1. Planning Board Meeting Materials 2026-01-05

AGENDA
York Planning Board Meeting
January 5, 2026
7:00 PM
York Public Library

RE: Grand View Hotel- Site Plan – Field Change Request

SITE PLAN
ELECTRIC LIGHT COMPANY, INC.
1 MORGAN WAY, CAPE NEDDICK, ME

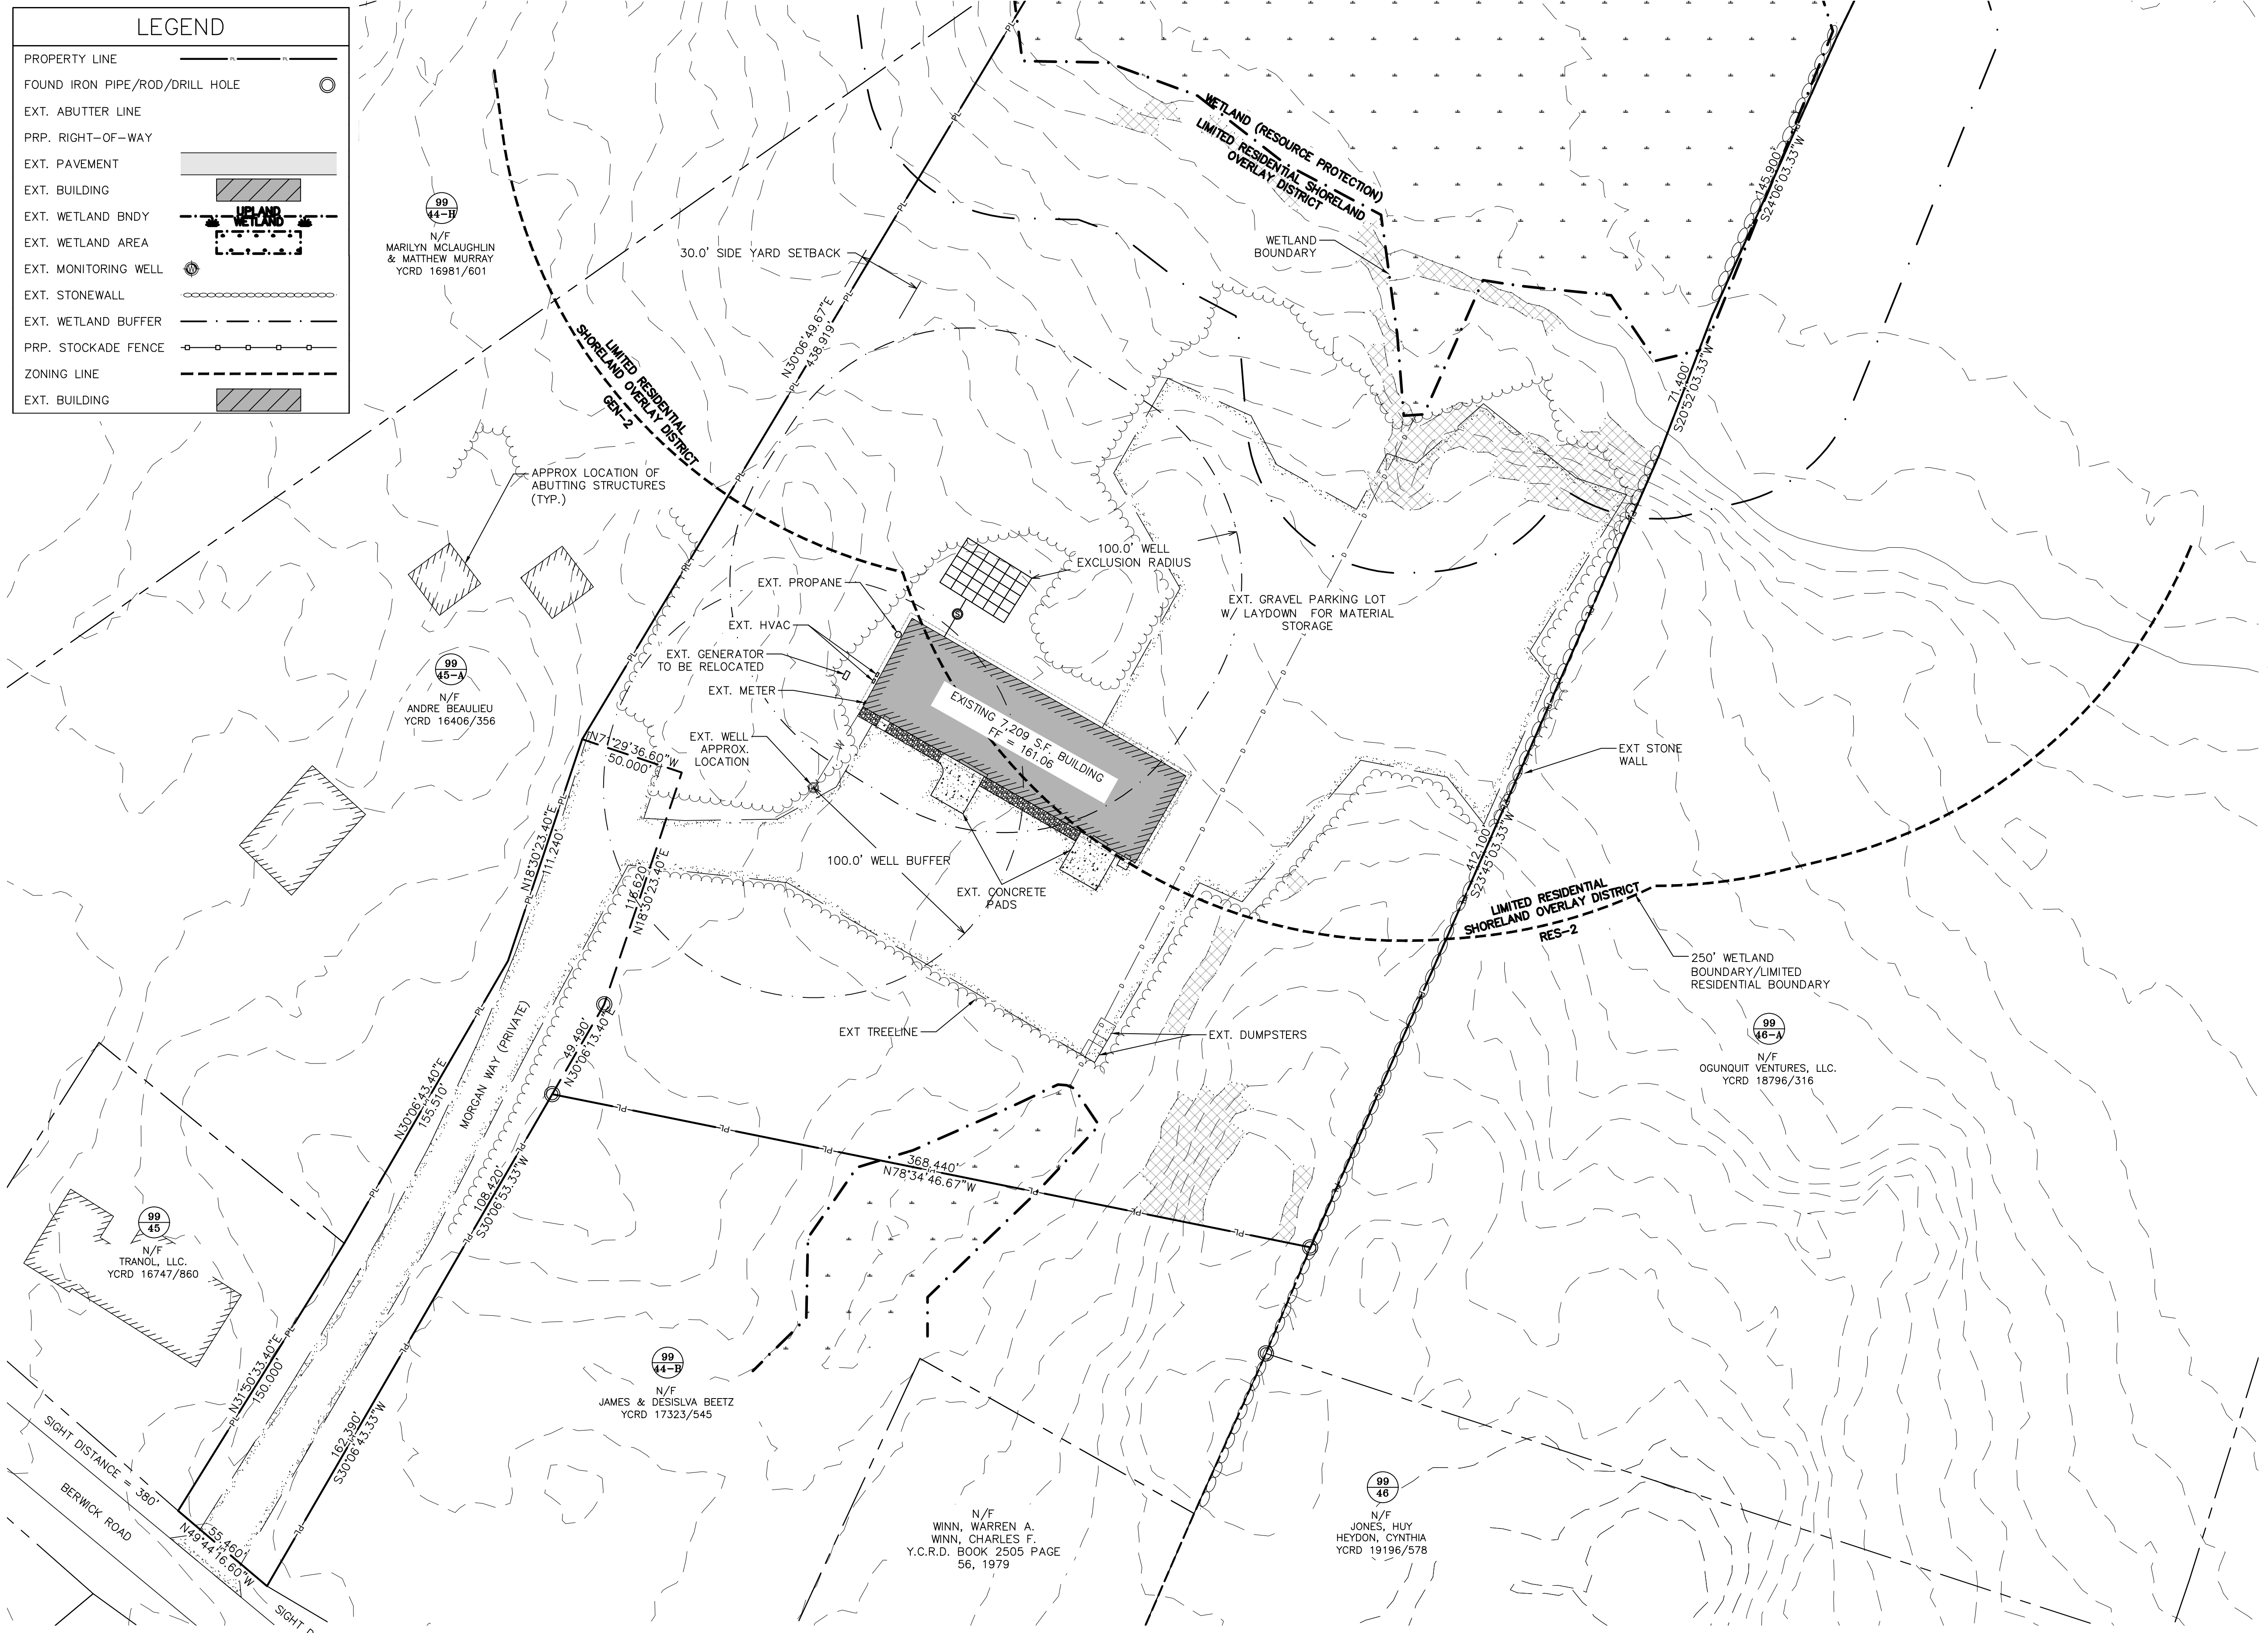
6. Demonstration of total impervious surface ratio and coverage is not entirely clear and needs further clarity and information. **The plans have been revised. The additional calculations, however, (Plan Note 5 on sheet 2) are not clear. (see comment 2.b below)**

- b. In the GEN-2 zone there is a requirement not to exceed 25% impervious surface ratio for the lot. [and 20% for the area within the Shoreland Overlay Zone subdistrict Limited Residential per Article 8]. The plans (Sheet 2, Site Plan) appear to only include the buildings in the coverage calculations. See the Definitions section of the Zoning Ordinance for more information on calculating 'Impervious Surface Ratio'. The applicant has revised the plan, however, the calculations, (Plan Note 5 on sheet 2) reflect only gravel area for coverage (under 'PRP. SHORELAND..') and the note below states 'no additional impervious area' in the shoreland zone. The plans reflect approximately half the existing building within the shoreland zone, but the area doesn't appear to be reflected in the shoreland calculations. The riprap associated with the stormwater pond should be reflected in the total coverage amounts. The Applicant should confirm and revise accordingly.

GRADING & UTILITY PLAN
ELECTRIC LIGHT COMPANY, INC.
1 MORGAN WAY, CAPE NEDDICK, ME

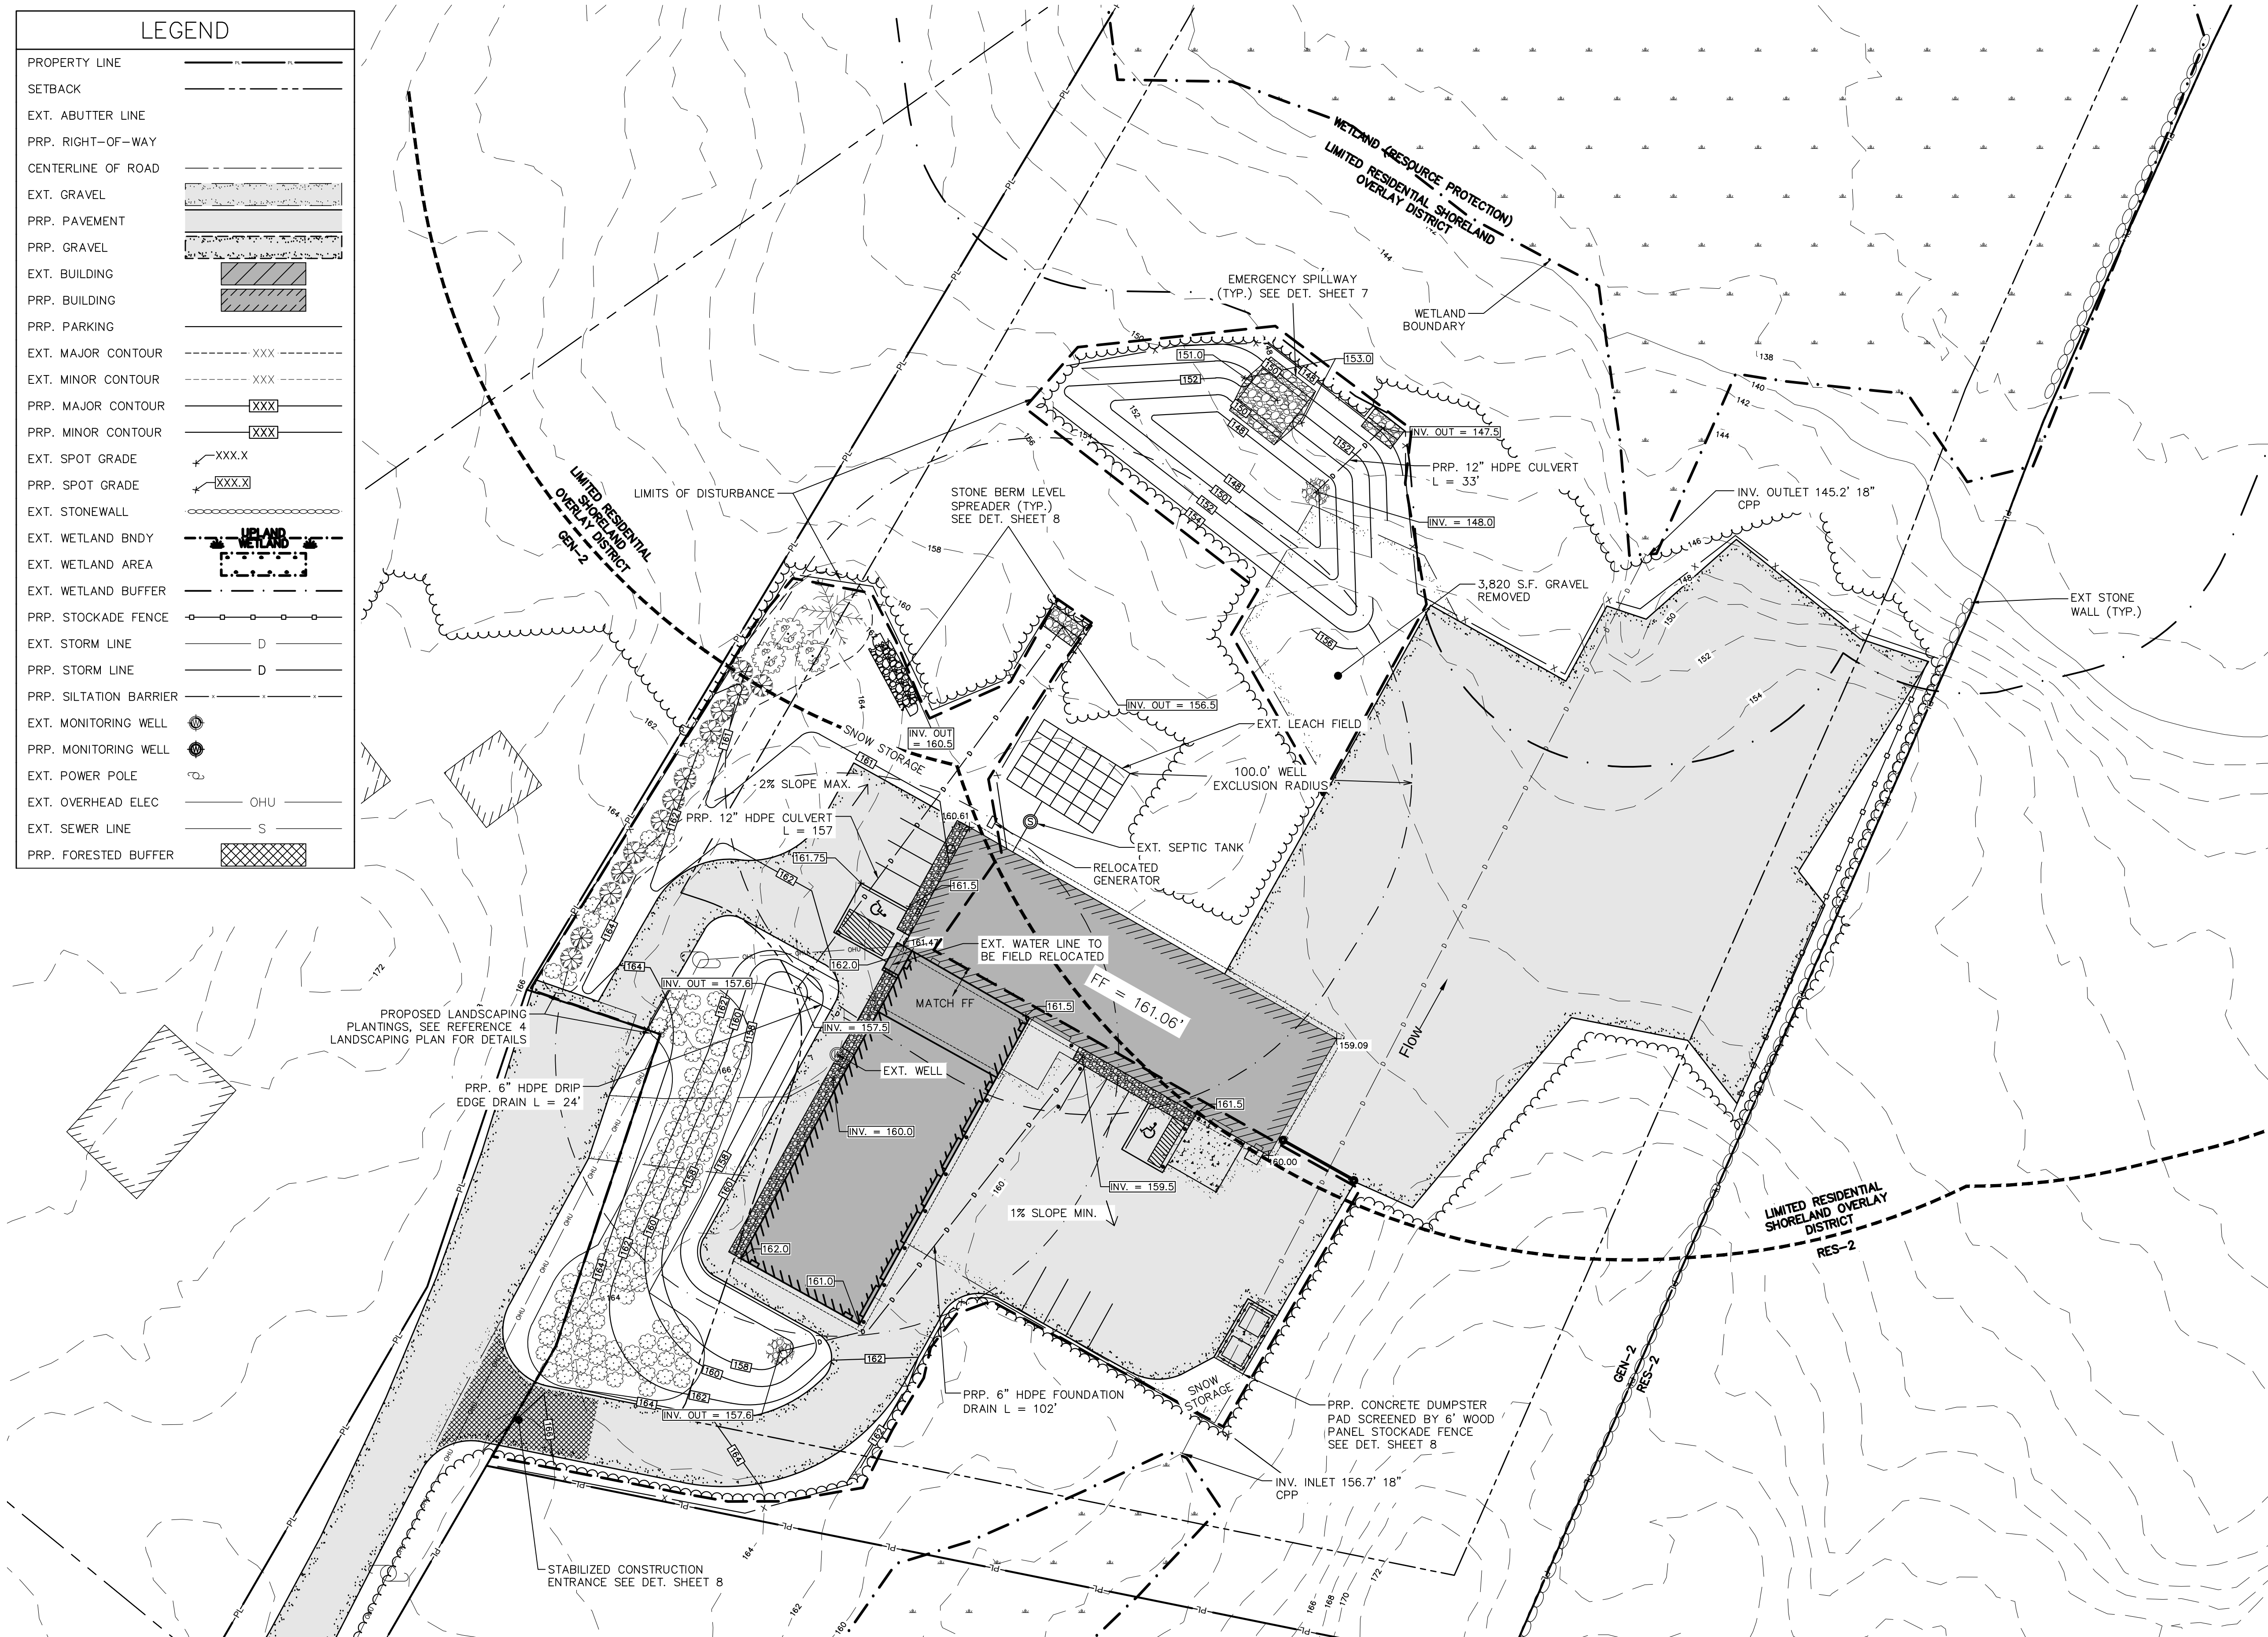
E	ADDED LEVEL SPREADER TO SWALE AS PER GP	11/26/25
D	PLANNING BOARD REVS	10/23/25
C	PLANNING BOARD REVS	9/5/25
B	PLANNING BOARD REVS	1/6/25
A	TOWN PLANNER REVS	7/24/24
NO.	DESCRIPTION	DATE
	REVISIONS

(6.4.15.1)
 - i. This comment has been addressed on Sheet 4.
